## **REMARKS**

In the Action, paper no. 7, the drawings were objected to as lacking clarity. The Applicant submits formal drawings, which have been rendered to provide a clear disclosure of the invention. No new matter has been added.

Proposed Drawing Changes FIG.8

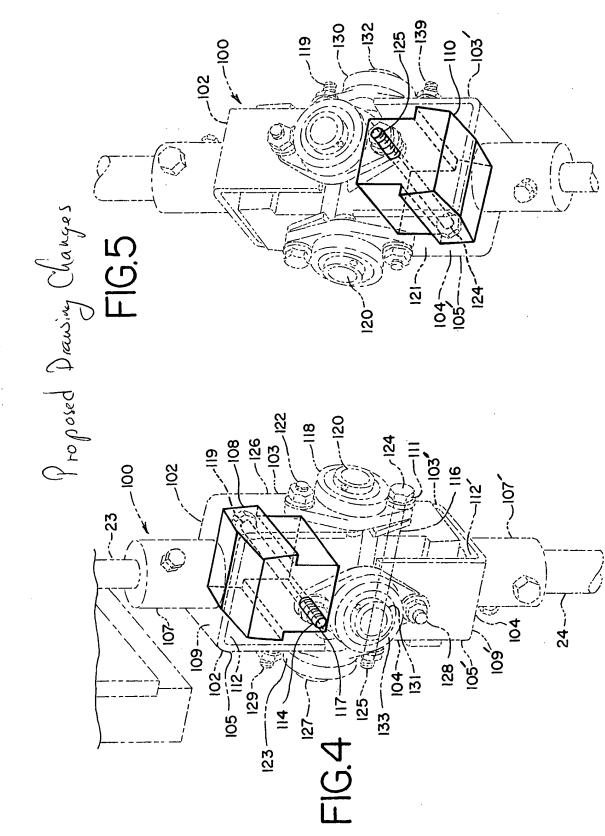
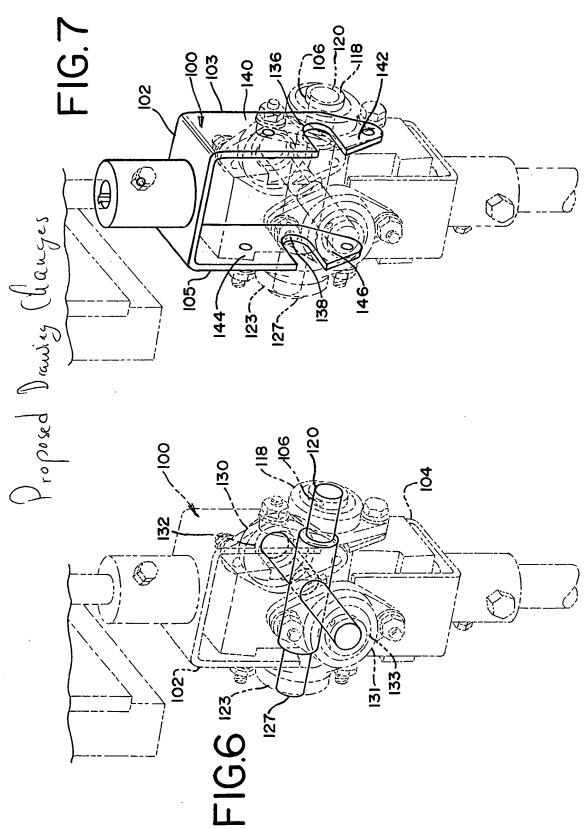
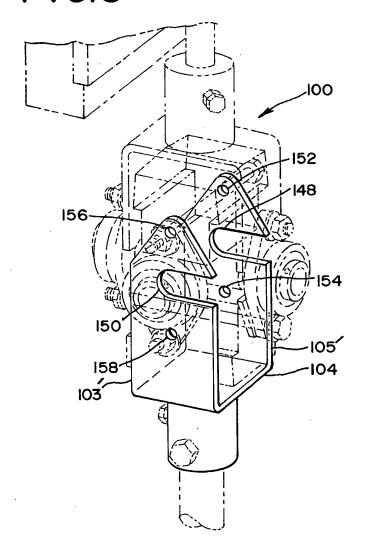
The drawings were also objected to as using reference numerals to indicate more than one element, i.e., 103, 105, 107, 109 and 112. Proposed drawing corrections are submitted herewith which label the elements on the second yoke (104) as 103', 105', 107', 109' and 112'. The formal drawings referred to in the above paragraph incorporate the proposed drawing corrections.
